Re: Greenough Heights Subdivision

Development Services received your application packet for the above subdivision for *1st Element Review* on June 24, 2021. The element review deadline is July 1, 2021. **At this time, Development Services cannot certify your application packet as containing all the necessary elements.**

Re: Greenough Heights Second Element Submittal

Re: Greenough Heights 20-lot Subdivision, 1006 W. Greenough Drive, 1st Sufficiency Review

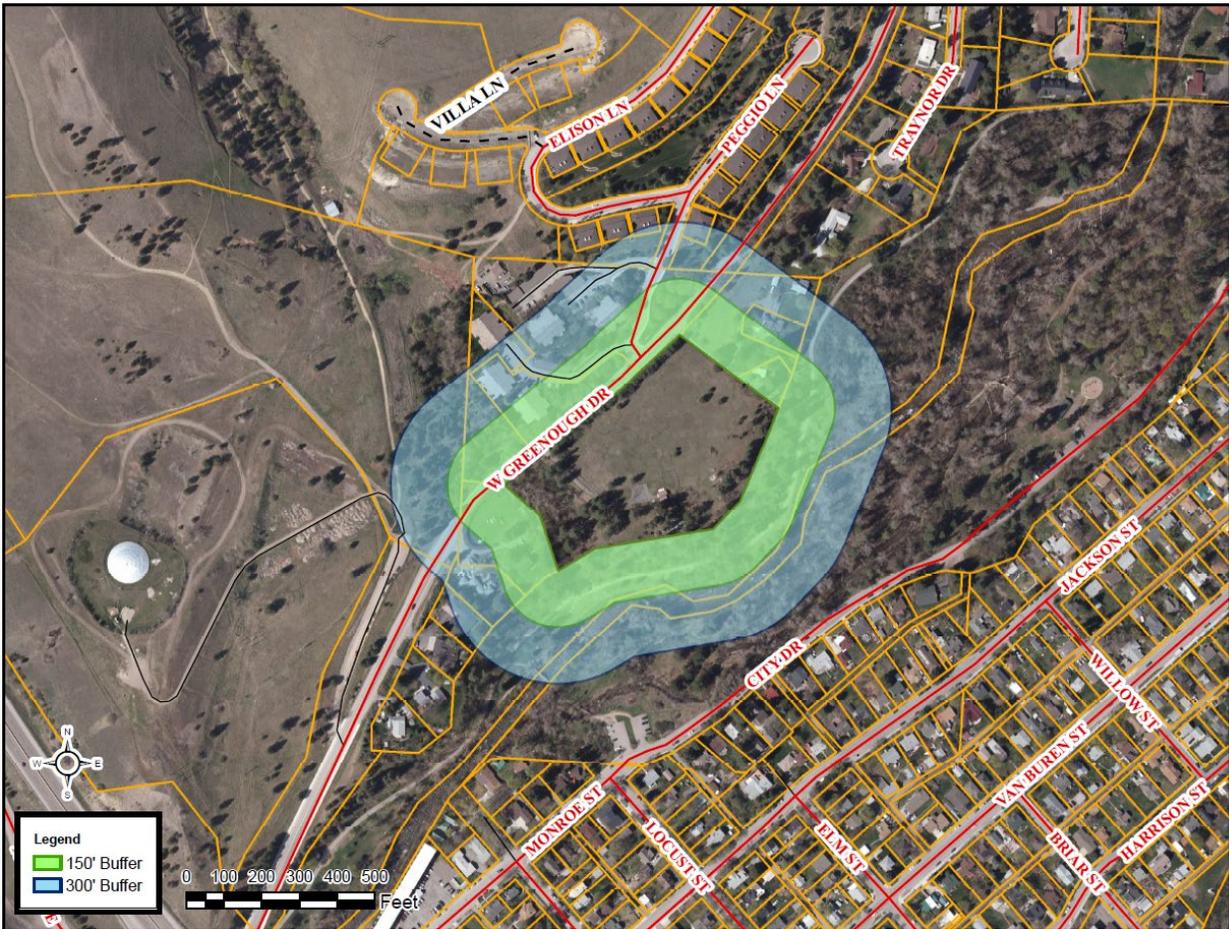
- u)** Regarding Neighborhood Meeting requirements: Please provide proof of posting within 300 feet of the subject property as well as mailing notices as required in City Subdivision Regulations Section 4-010.2. See below map for details.

Please see updated Neighborhood Meeting information in Section E. This now contains all invites sent, list of all invites sent, pictures of signs, map showing location of properties that were contacted.
